Re: St. Lucie Unit 2
Docket No. 50-389
Response to Request for Additional Information Regarding the Spring 2014 Steam
Generator Tube Inspections

RESPONSE TO REQUEST FOR ADDITIONAL INFORMATION
REGARDING THE SPRING 2014 STEAM GENERATOR TUBE
INSPECTIONS

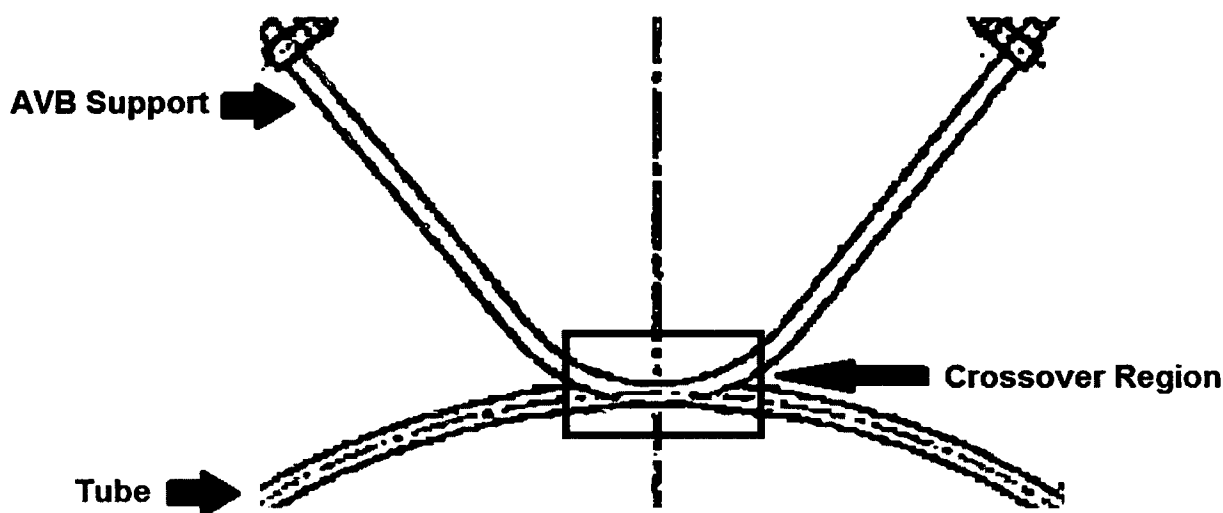
One tube was plugged since it had wear associated with a neighboring tube's V-shaped support pad. Has this phenomenon been observed in the past? Are the V-shaped support pads in close proximity to the neighboring tubes? Would this occurrence be expected given the design (rigidity) of the anti-vibration bar support structure and the spacing between the tubes?

The tube discussed in the RAI is in Row 91 Column 24 (R91C24) in SG-A of the St. Lucie 2 RSGs and had a wear indication created by contact with the side of the adjacent (neighboring) V-shaped support pad at AV7+18.38, which is in close proximity to the AV8 location. The tube that is supported by the V-shaped support pad is Row 90 Column 23 (R90C23).

This indication (R91C24) is the first reported occurrence of this type of wear. The V-shaped support pads are designed to be in very close proximity to the adjacent tubes (i.e. neighboring tubes). The AVB bars and V-shaped support pads are located at different axial elevations. Contact between a V-shaped support pad and the adjacent tubes is not expected by design. The contact between the V-shaped support pad and the neighboring tube is most likely due to a misalignment of the V-shaped support pad during manufacturing. With this misalignment, it is then possible that the V-shaped pad that is supporting tube R90C23 to induce wear on the adjacent tube (R91C24).
